MEMORANDUM

SUBJECT: Response to Comments for Traffic Impact Study - Loudoun County Public Schools
Lenah Property MS-5 and HS-7; SPEX 2008-0017 and CMPT 2008-0007

This document addresses the second referral comments received from **VDOT** for the traffic impact study prepared for Loudoun County Public Schools, Lenah Property MS-5 andHS-7; SPEX 2008-0017 and CMPT 2008-0007, Loudoun County, Virginia. Each comment is presented in *italics* with the response in **bold** immediately following.

Right Turn Lane Warrant Analysis (2-LANE)

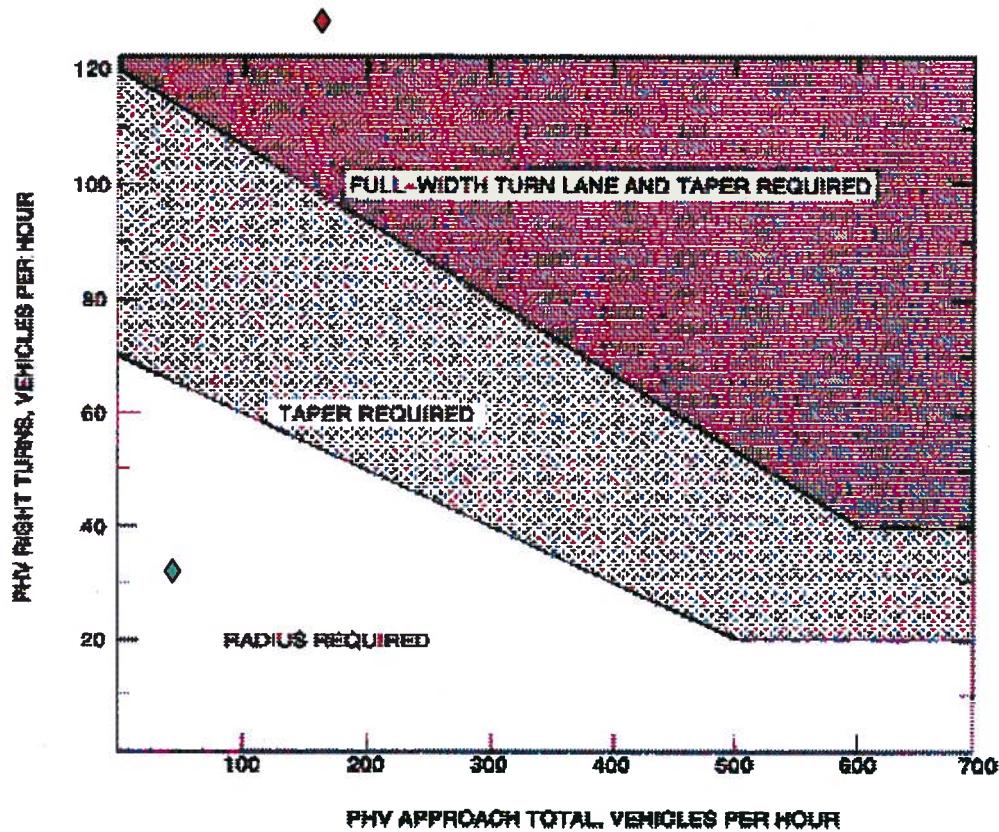
- 9) *On Page 3 of the response document, the engineer fails to discuss/address the northbound right turn lane at the intersection of Rt. 50 and Lenah Road. This turn lane has been identified as a planned/recommended improvement due to site in the February 15, 2008 TIA. Please ensure this movement is included as a needed movement as a result of site generated traffic.*

The northbound right turn lane is 'warranted' under the existing conditions. The table below from the memorandum dated July 16, 2008 addressing the comments received from VDOT shows that the traffic volume under existing conditions warrants the northbound turn lane. The warrant analysis spreadsheet is shown on the next page.

Right Turn Lane Required.

Intersection # 7: Lenah Road and Site Drive # 2

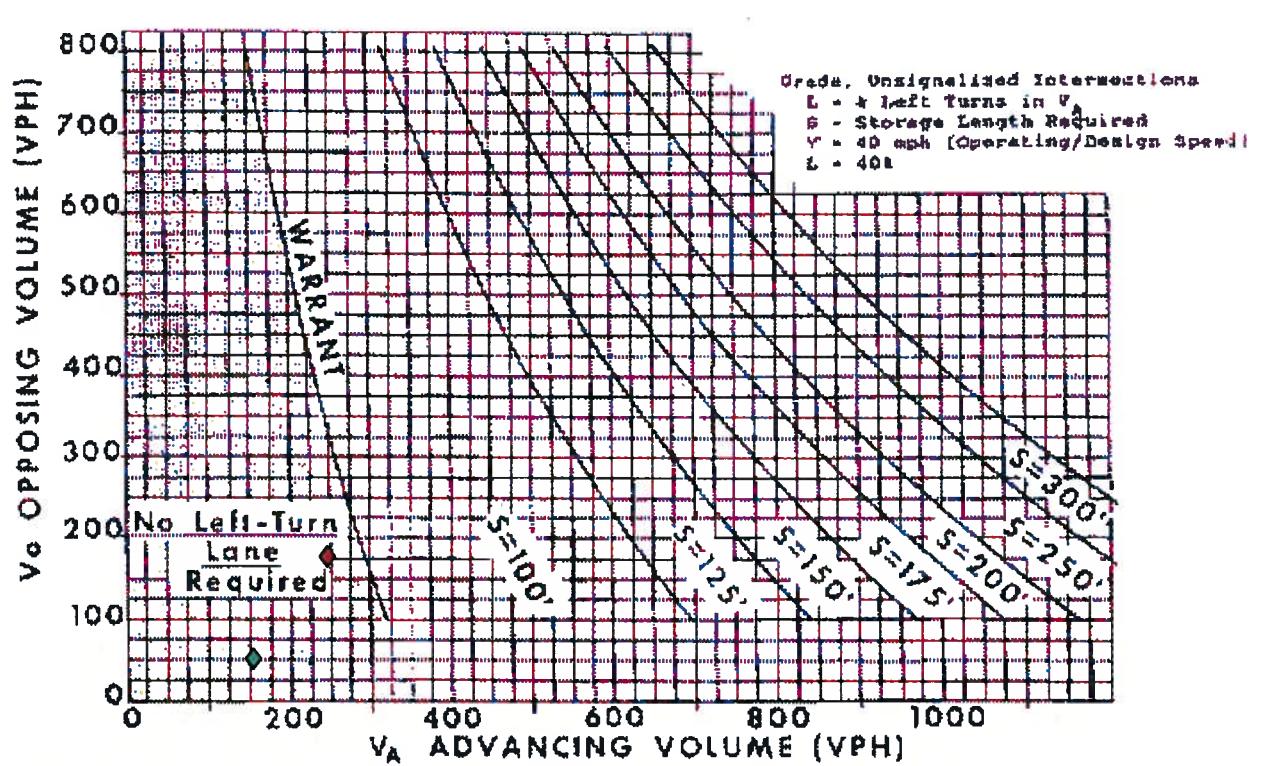
- iii. Even if PCE factor is not used, which we still strongly recommend to be used for consistency and accuracy, a WBL at intersection 4 and Intersection 7 is warranted. Please revise the analyses and resubmit.

Comment acknowledged. The left turn lane warrants for intersections 4 and 7 were reanalyzed based on VDOT's comments. The results reveal that a left turn lane is not warranted at intersection 7. The warrant analysis reveals that a left turn lane is barely warranted at intersection 4. Although, it should be noted that, the proposed site circulation plan will not allow any buses to enter intersection 4. LCPS separates the car and bus traffic to facilitate traffic flow at the proposed facilities. Intersection 4 serves the car parking lot. The bus traffic is directed to intersection 7 to the separate bus loop that will be located on the north side of the school.

Left Turn Lane Not Required.

TRAFFIC SIGNAL WARRANTS (Lenah Loop Road and Braddock Road, TF 2020)

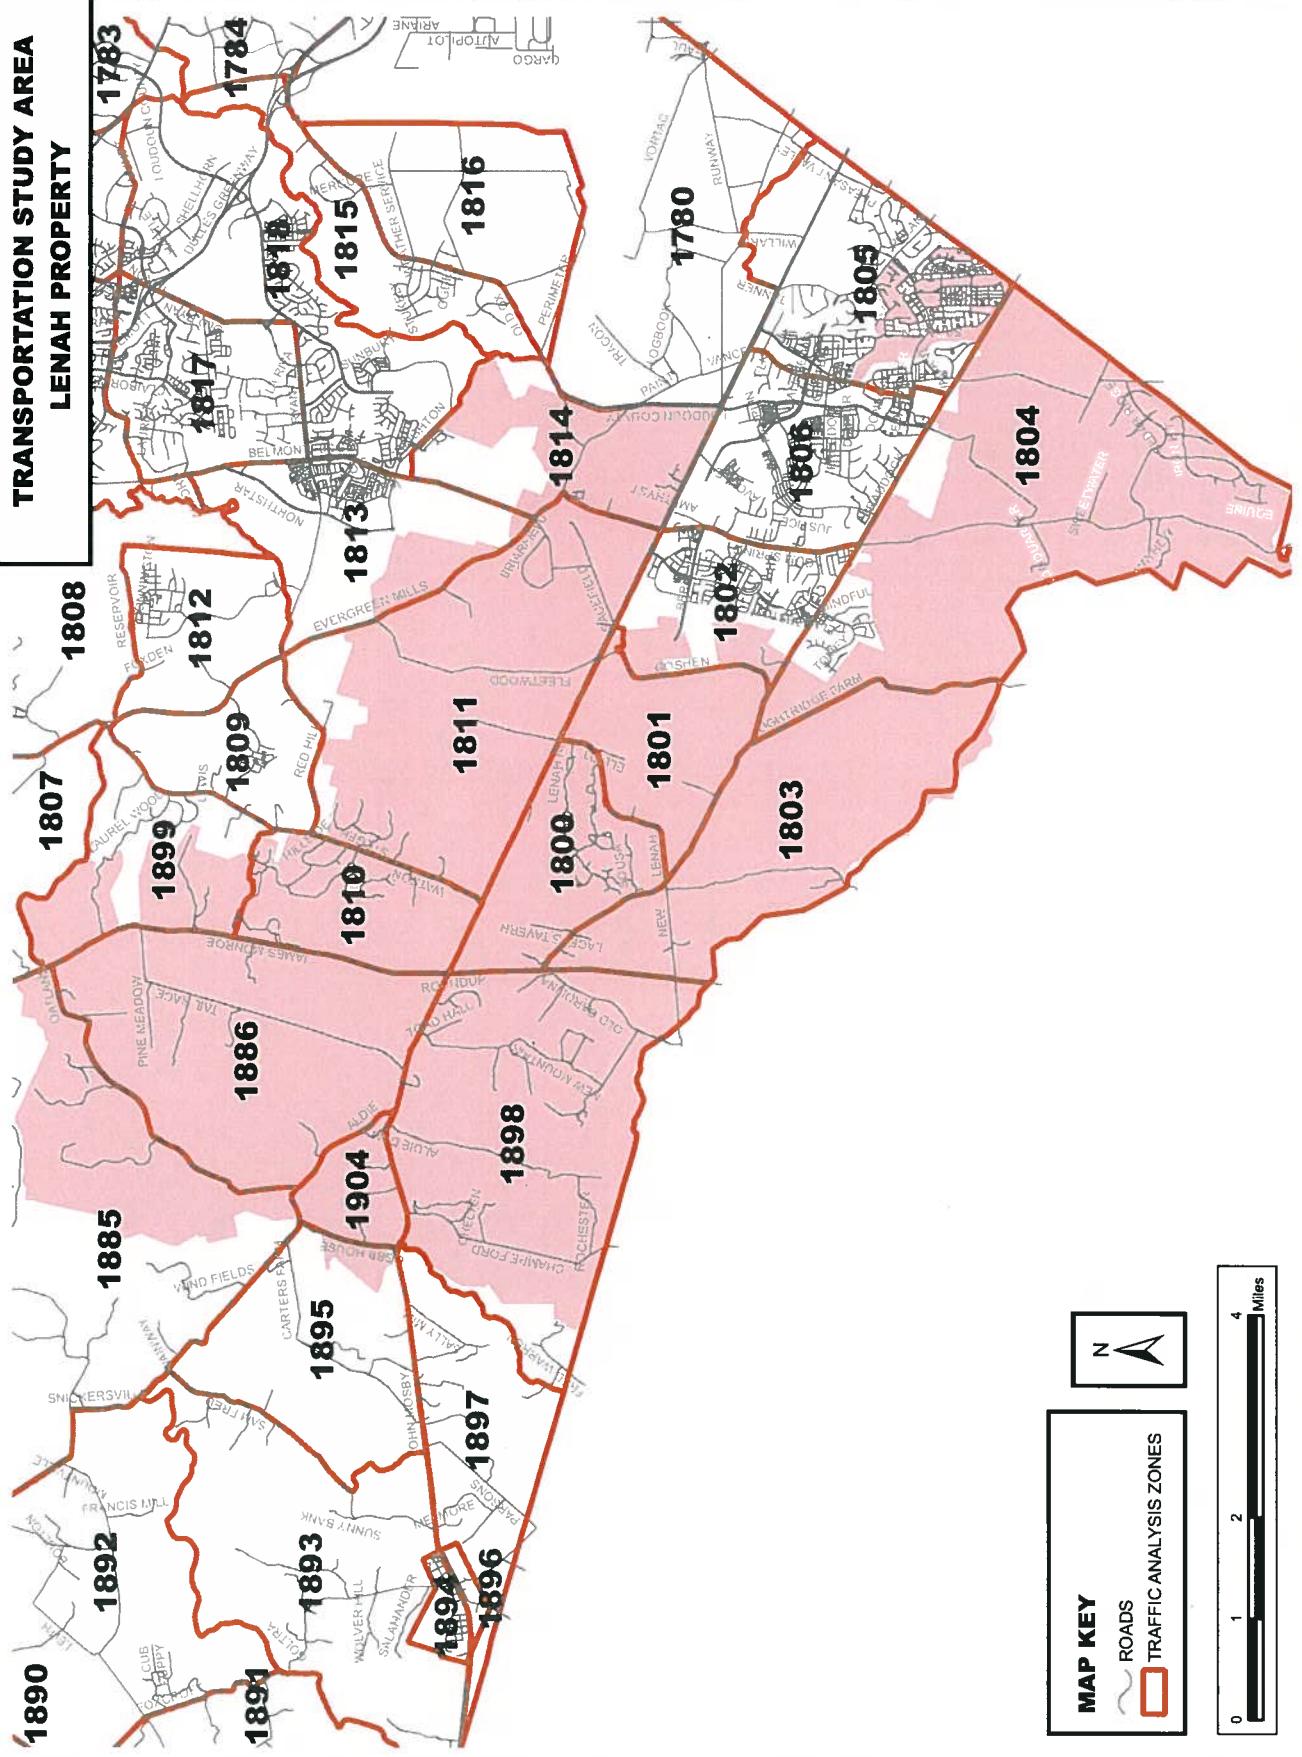
- a. *Intersection of Route 50 and Lenah Road – Add traffic signal*
- b. *Intersection of Route 50 and Lenah Road – Add westbound left turn lane*
- c. *Intersection of Route 50 and Lenah Road – Add eastbound right turn lane*
- d. *Intersection of Route 50 and Lenah Road – Add northbound right turn lane*
- e. *Intersection of Braddock Road and Lenah Connector (aka, Lenah Loop Road) – Monetary contribution towards traffic signal.*

With regard to the contribution to a signal at the intersection of the Lenah Connector Road and Braddock Road, the traffic study found that a signalization is required from an operational point of view. The next step outlined by the VDOT guidelines is to check whether the signal is warranted based on the traffic volumes projected at that intersection. The warrant analysis reveals that a signal is not warranted under the 2020 traffic scenario. The warrant analysis MTSD spreadsheet is attached at the back of the memorandum.
